**COUNTY OF VENTURA
PUBLIC WORKS AGENCY**

From: Gregg Strakaluse **Addendum No.1**
Director of Public Works

Subject: **Project Name: E.P. Foster Library Modernization**
Specification No. CP24-01
Bids to be Opened: Thursday, January 8, 2026 is changed to
Wednesday, January 14, 2026

1 First Floor Plan - Demolition
SCALE: 1/8" = 1'-0"

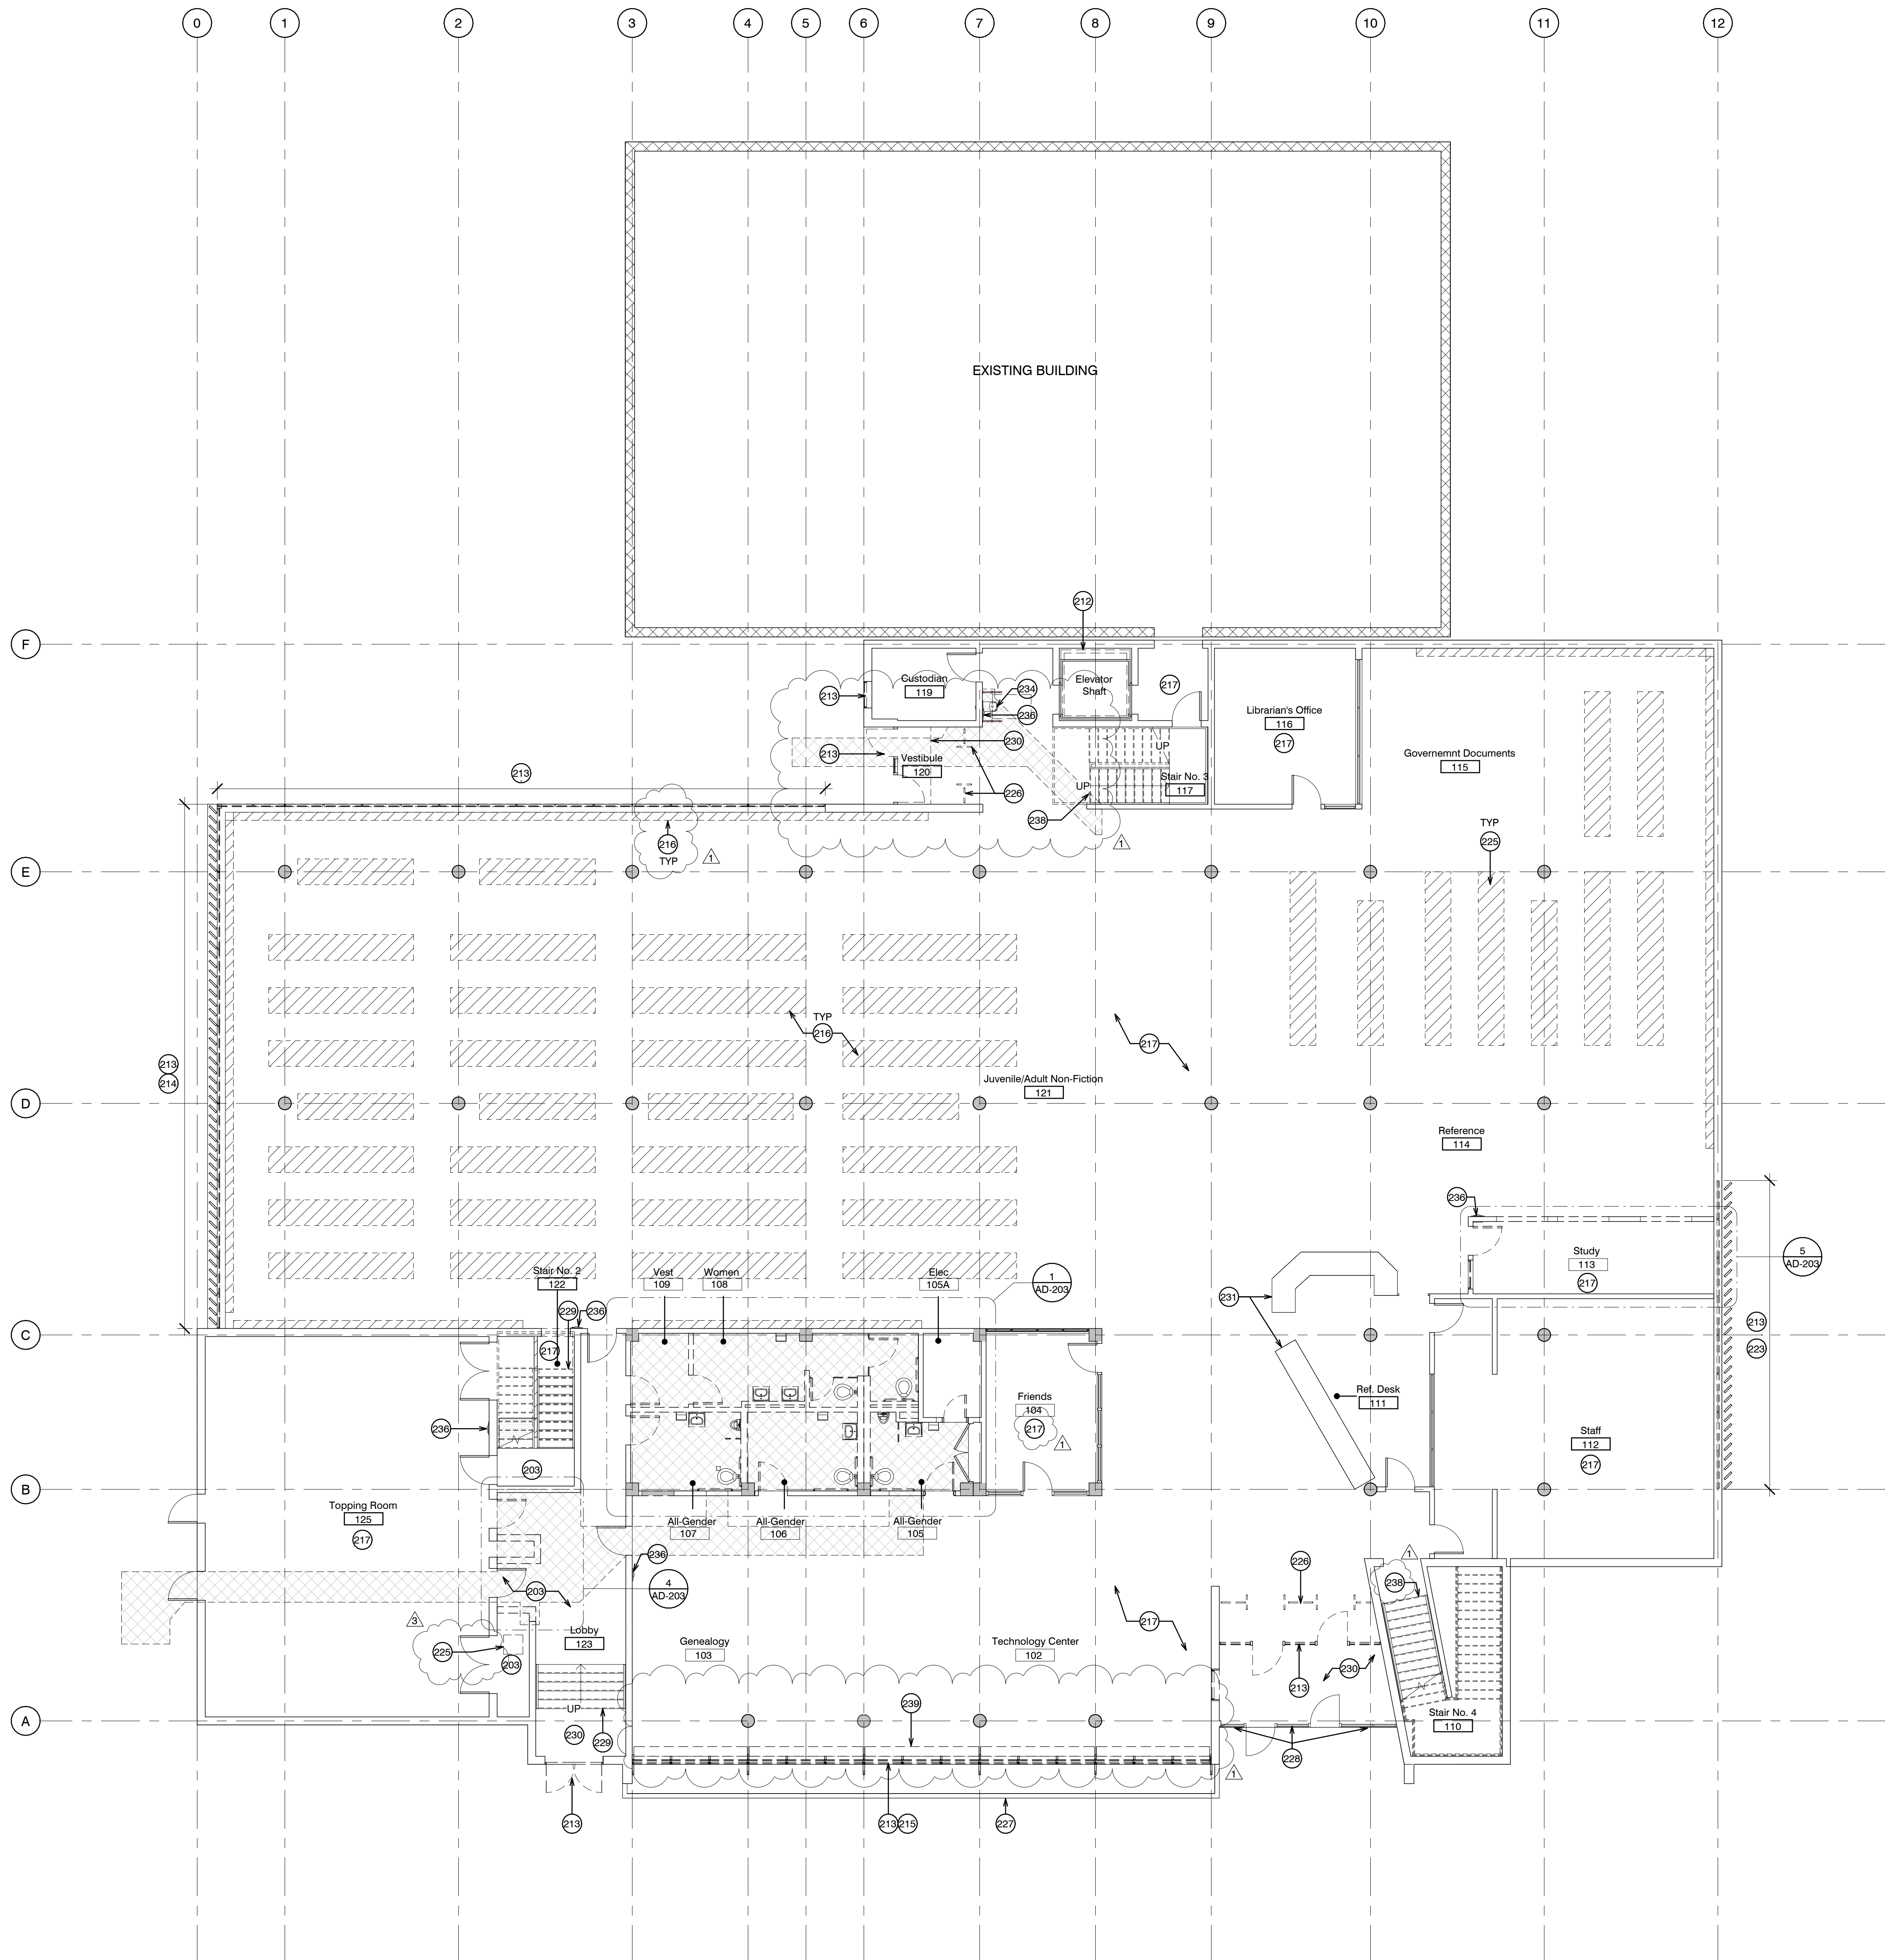
1. Replace Sheet AD-201 – Demo First Floor Plan with the attached Addendum No. 1 plan Sheet AD-201 – Demo First Floor Plan.
Explanation: See cloud revisions. Keynote 217 has been revised to remove the existing carpet & linoleum down to concrete substrate. A new keynote 225 has been added to indicate the removal and replacement of the existing roof hatch and access ladder with new ones in the Topping Room closet.

SITE PLAN

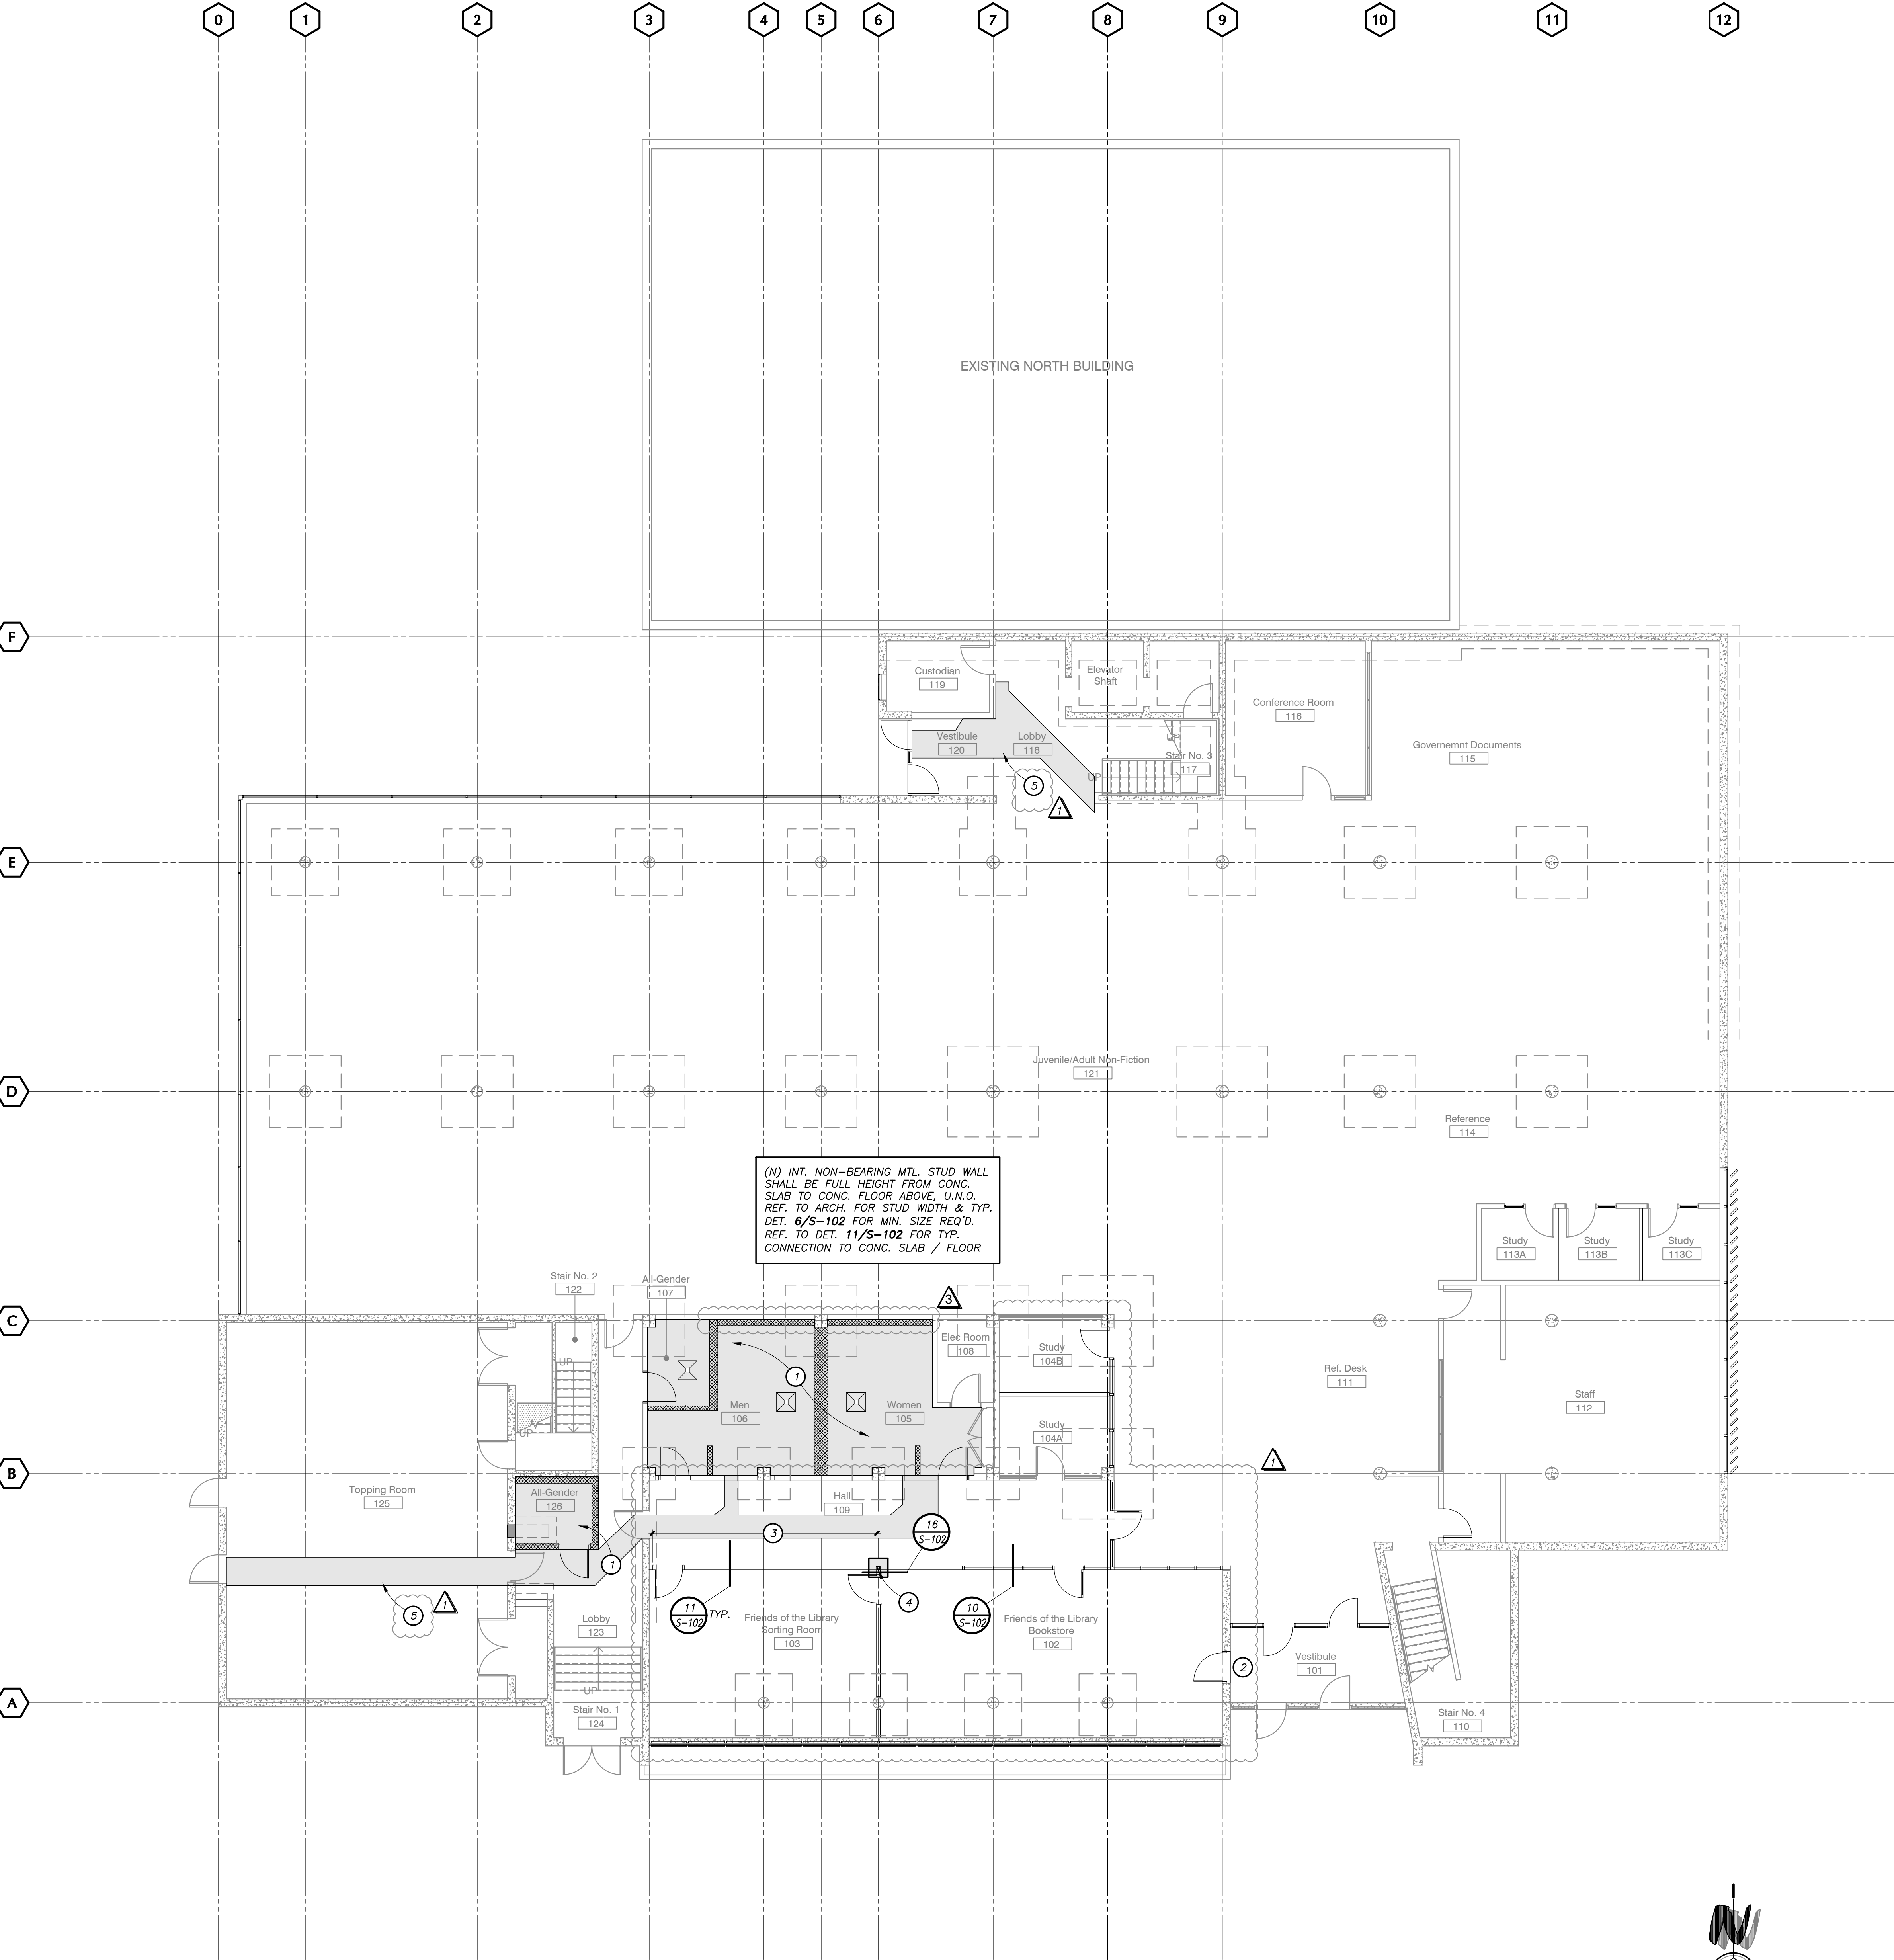
4. Replace Sheet A-101 – Site Plan with the attached Addendum No. 1 plan Sheet A-101 – Site Plan.
Explanation: See cloud revisions. The existing ramp near the Topping Room has been revised to show a new ramp, and keynote number 111 has been added to indicate the new ramp. The enlarged plan indication is noted as 2/A-103 for the new ramp
